Clause 94 comment resolution  
Addresses various comments

IEEE P802.3bj, January 2012, Phoenix  
Matt Brown – AppliedMicro

# Noise power spectral density (PSD) template #1

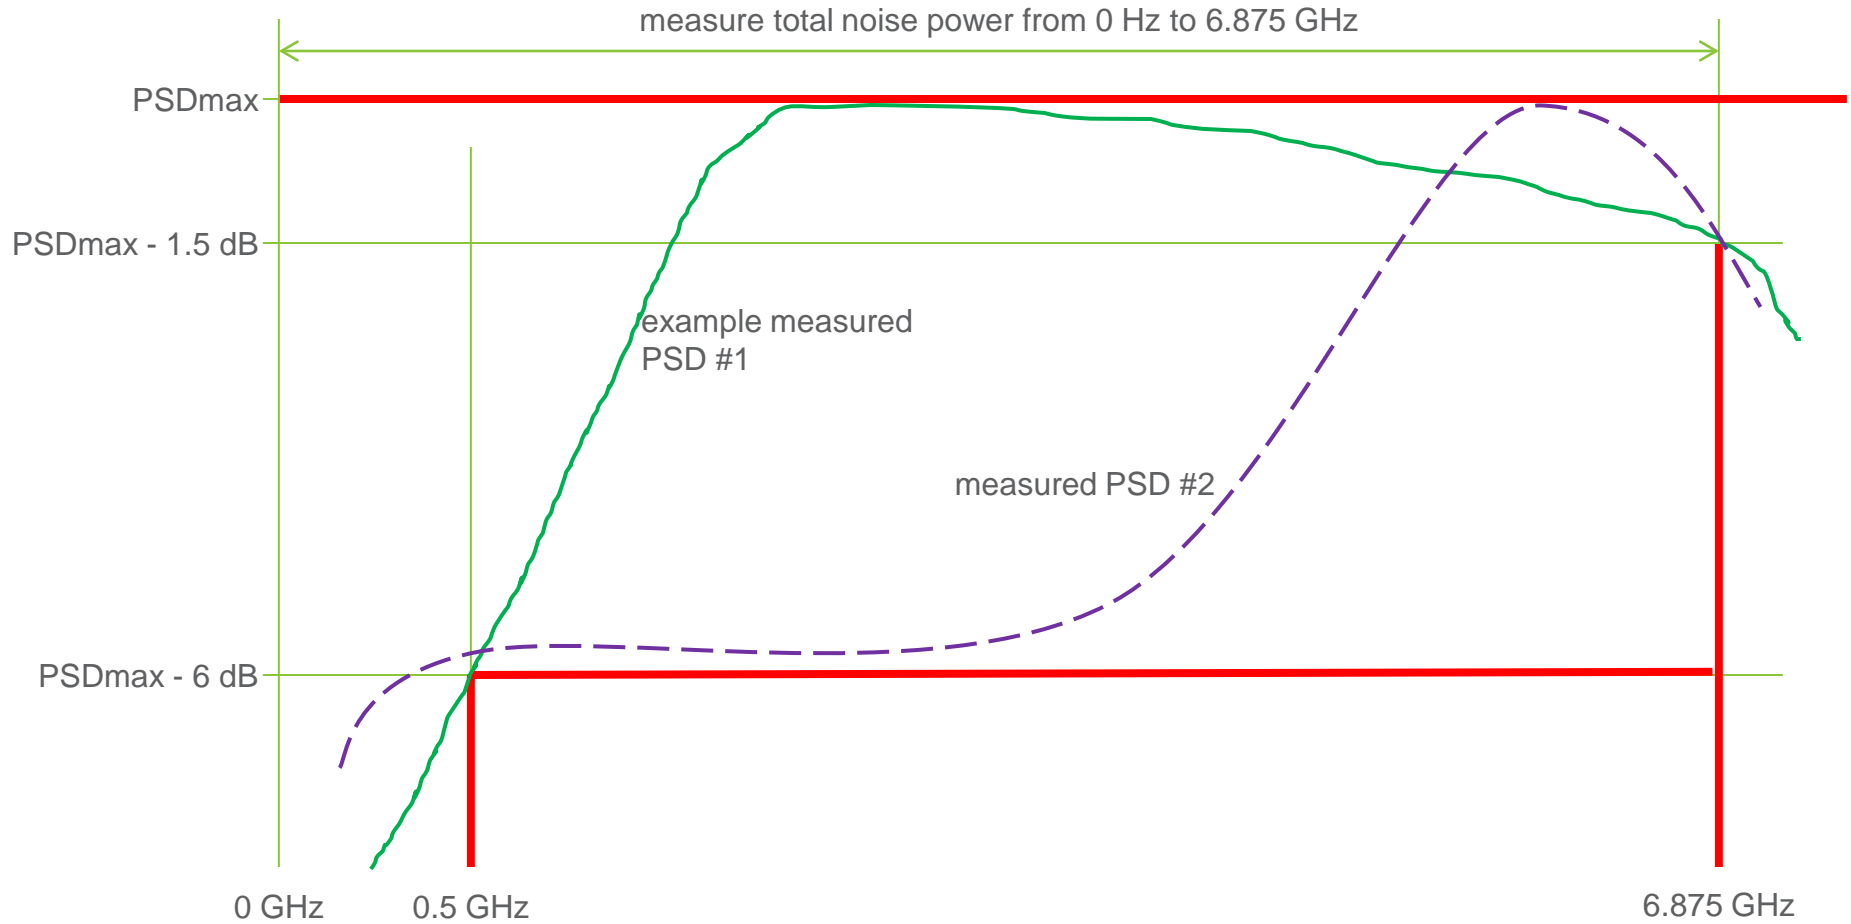
CI 94	SC 94.3.13.4.1	P 277	L 32	# 19
Moore, Charles		Avago Technologies		
Comment Type	T	Comment Status	X	
The test channel Gaussian white noise source is not well speced. It cannot be ideally white an Gaussian. Need limits.				
<i>SuggestedRemedy</i>				
Add to 94.3.13.4.1:				
The noise, measured at TP5A, due to the test channel Gaussian white noise source must have a crest factor at least 4 and be flat to within +/-3dB from 0.5 GHz to 6.875 GHz with the noise spectra density at 6.875 GHz no more than 1.5 dB below its maximum value. The added white Gaussian noise is the RMS value of the noise over the frequency range from 0 to 6.875 GHz.				
Proposed Response	Response Status		W	
[CommentType not specified. Set to T.]

The following slide show a spectral density template depicting the description in comment #19.

- Assuming template #1.
  - The noise, measured at TP5A, due to the test channel noise source must have a crest factor of at least 4 and shall vary by no more than +/-3dB from 0.5 GHz to 6.875 GHz with the noise spectral density at 6.875 GHz no more than 1.5 dB below its maximum value. The noise level is the RMS value of the noise over the frequency range from 0 to 6.875 GHz.
- Assuming template #2.
  - The noise, measured at TP5A, due to the test channel noise source must have a crest factor of at least 4 and must and a PSD(f) within a range bounded by PSDmax and a straight line from PSDmax minus 6 dB at 0.5 GHz and PSDmax minus 1.5 dB at 6.875 GHz (see Figure 94-xx). The noise level is the RMS value of the noise over the frequency range from 0 to 6.875 GHz.

# Noise power spectral density (PSD) template #2

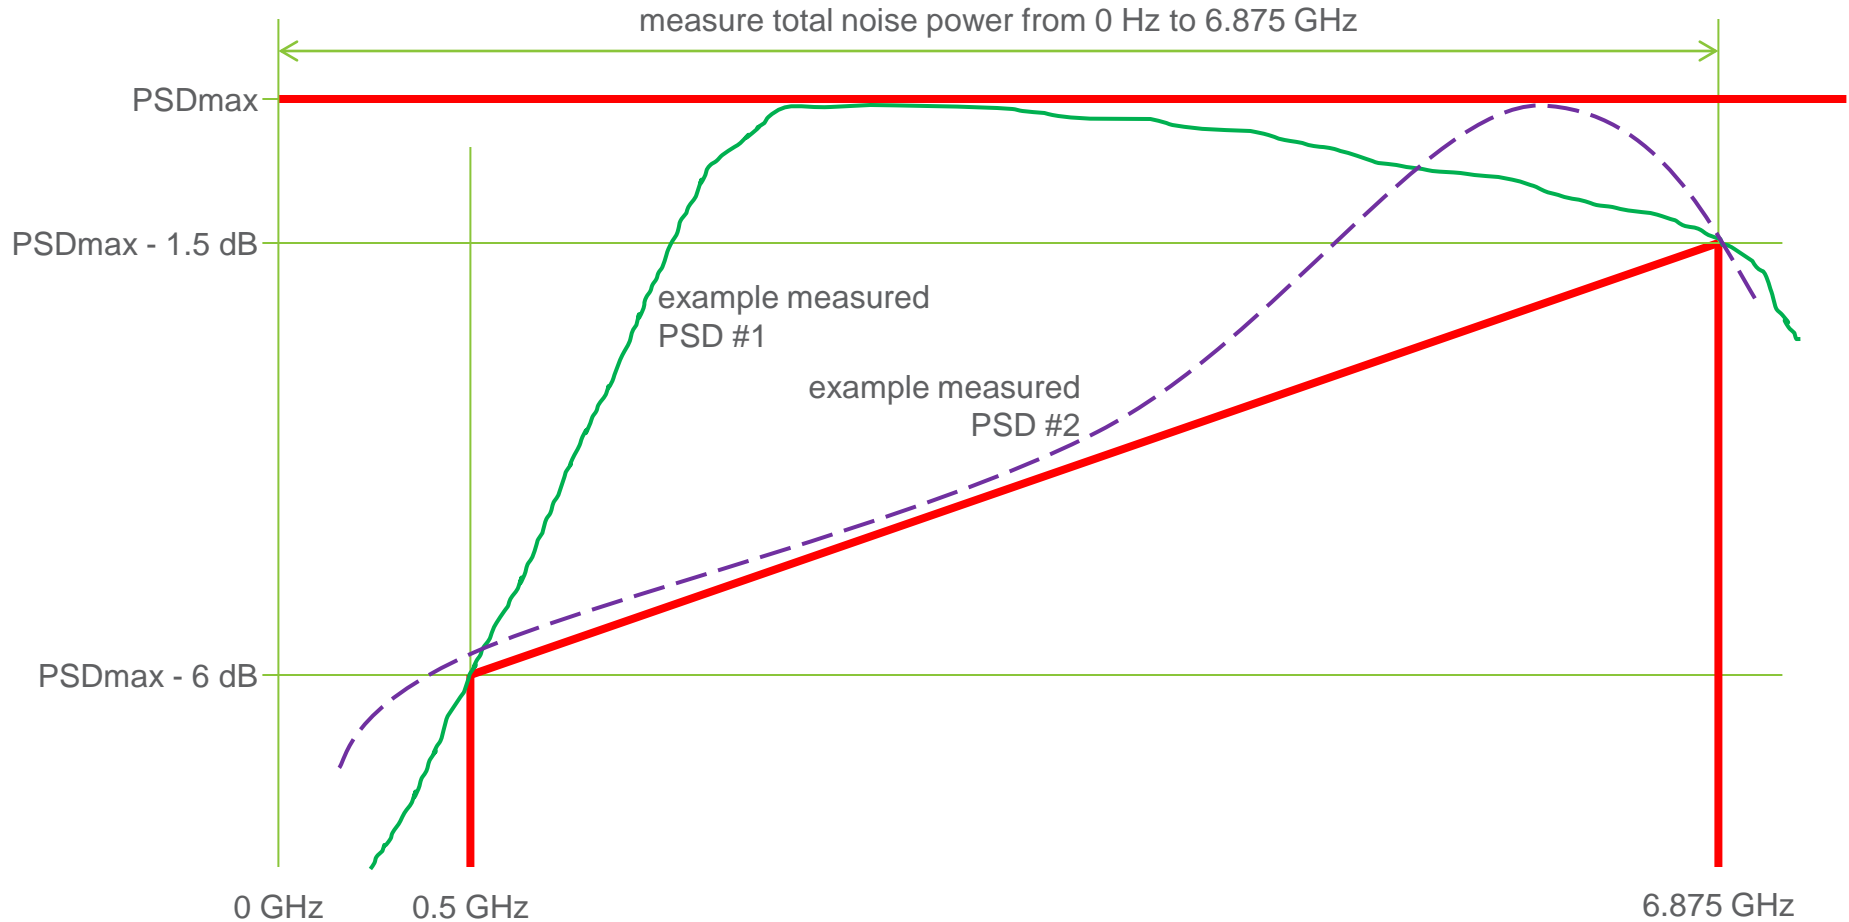
The subsequent slide shows an alternative template that provides the general qualities but bounds the spectral density a bit tighter.

- Which template style is appropriate?
- Other modifications?
- Is the noise white and/or Gaussian?
  - By allowance for +/- 3 dB variation over frequency, the noise is not flat in frequency, so it is not white.
  - Since the noise is truncated to a crest factor of 4 it is not Gaussian, though it may have a PDF similar to Gaussian to  $4 * \sigma$ .
